Addendum No. 1
Rock River Water Reclamation District
Rockford Southeast Trunk – South Branch
Capital Project No. 1965

This Addendum Number 1, dated August 30, 2019, for the above referenced project, supersedes all contrary and conflicting information in the specifications and contract documents, which are hereby supplemented or revised as follows:

ROCKFORD SOUTHEAST TRUNK - SOUTH BRANCH CAPITAL IMPROVEMENT PROJECT #1965

TYPICAL SECTIONS & PROJECT DETAILS

Sheet No.
7 OF 38

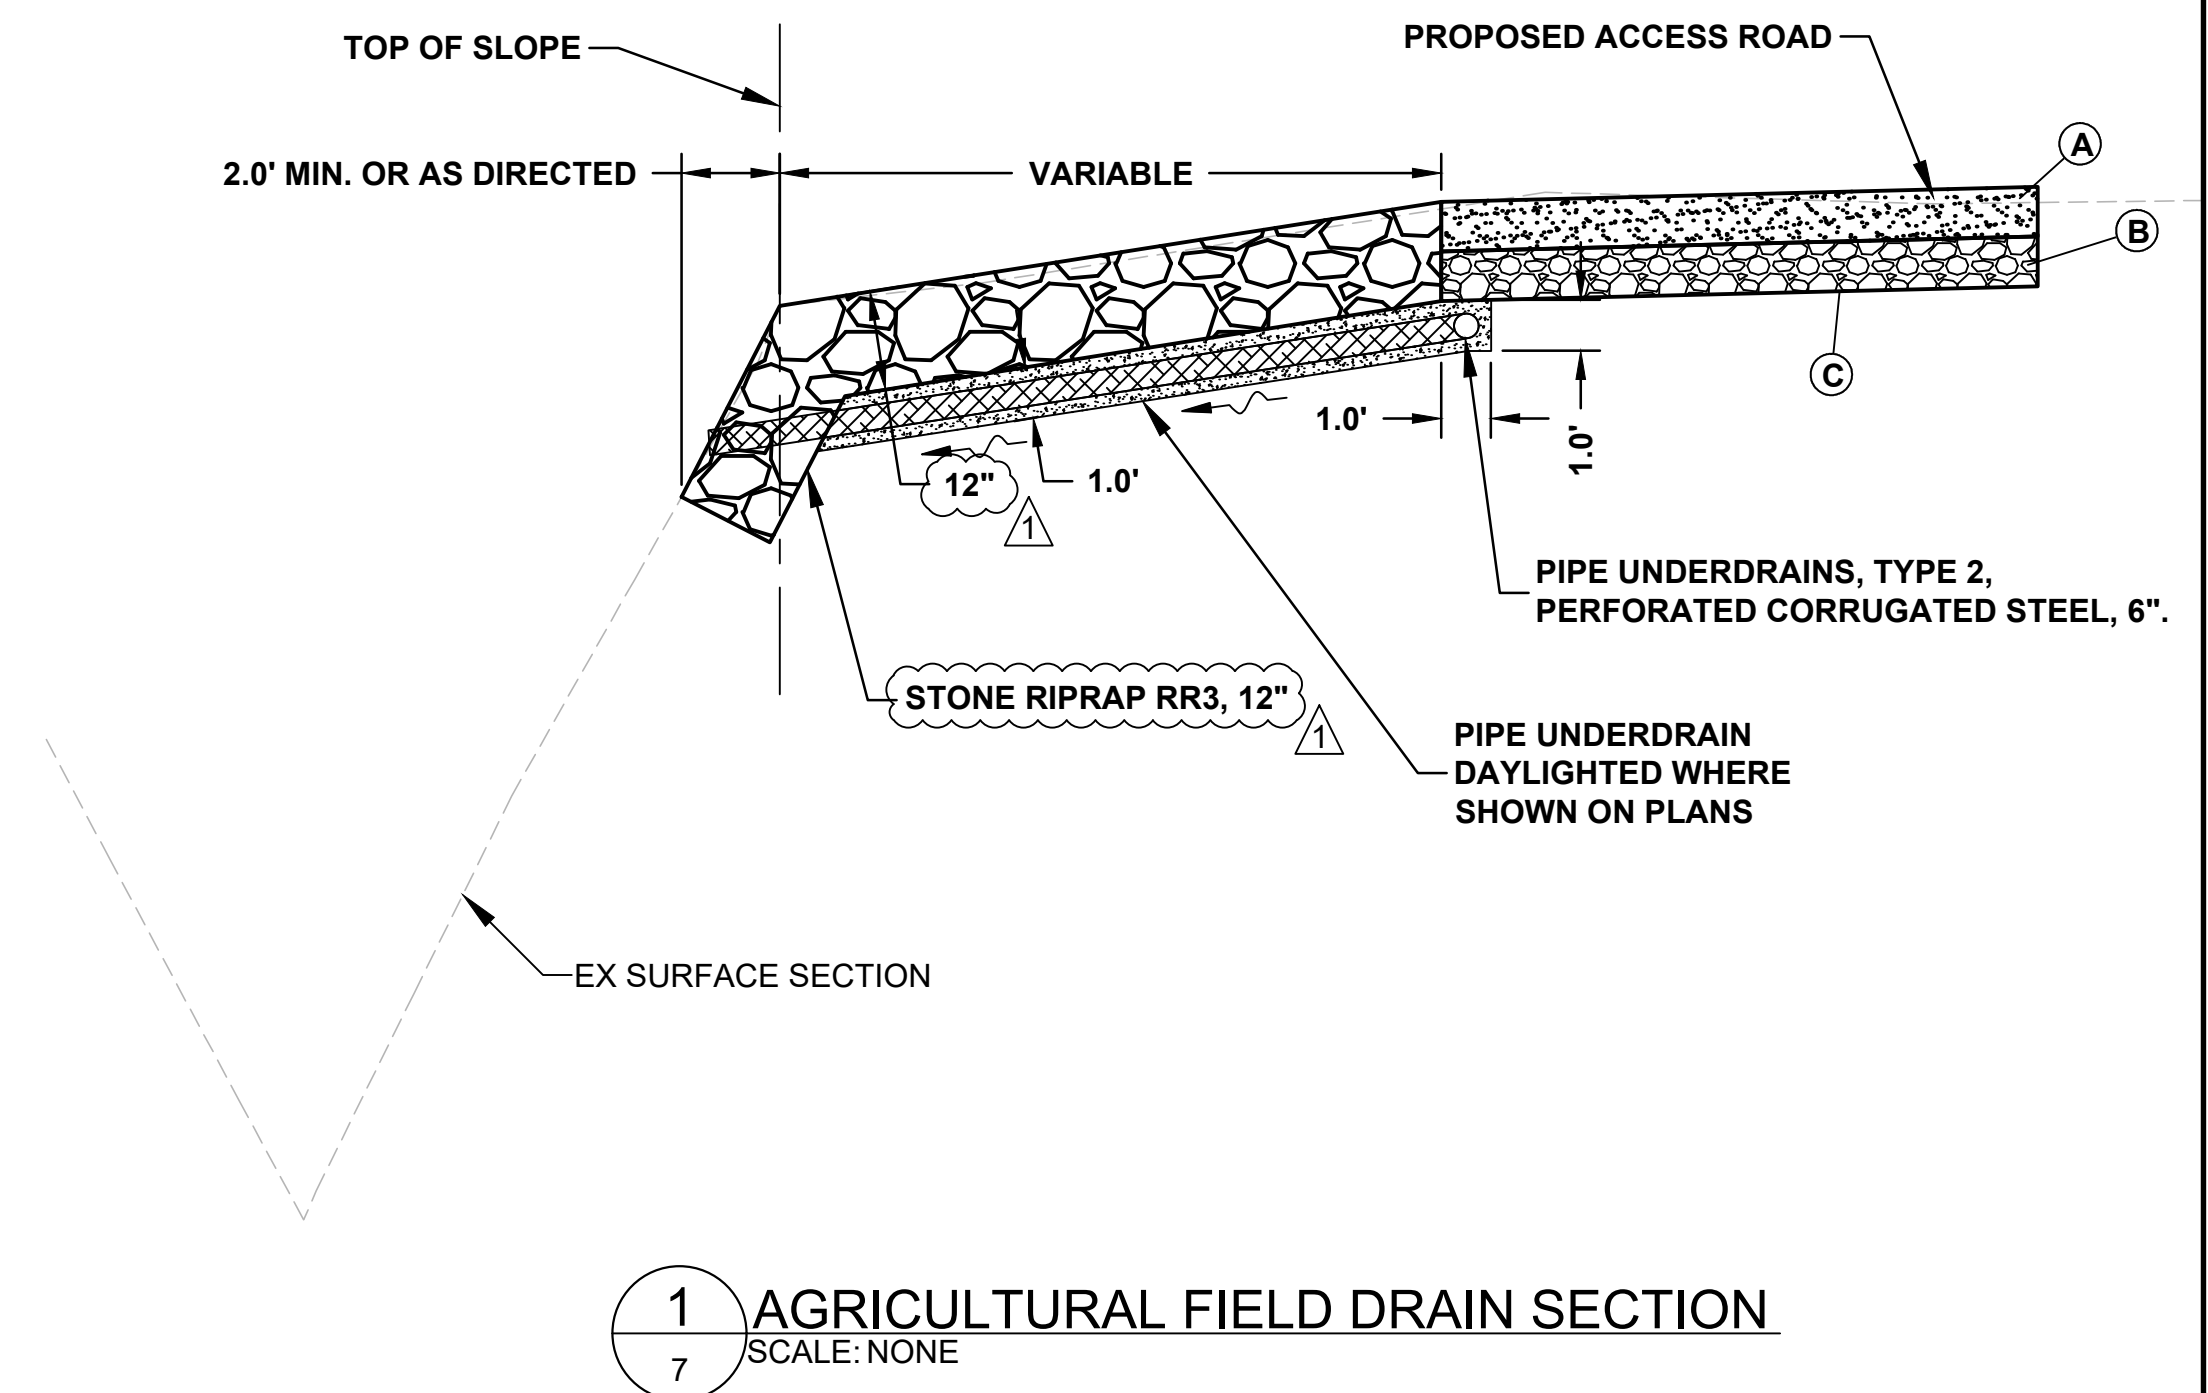
Sheet 7 of 38: TYPICAL SECTIONS & PROJECT DETAILS

1. The AGRICULTURAL FIELD DRAIN DETAIL and the AGRICULTURAL FIELD DRAIN SECTION have been updated to reflect that the depth of the STONE RIPRAP RR3 is 12".

- Daily Average Flow: 150,000 Gallons per Day (GPD)
 - Daily Maximum Flow: 375,000 GPD
- E. A question was raised regarding the thickness dimension of the Stone Riprap RR3 shown on Plan Sheet No. 7; they pay item reflects a depth of 12" while the detail shows a depth of 24". The proposed depth should be 12"; a revised plan sheet will be included with Addendum No. 1 reflecting this correction.
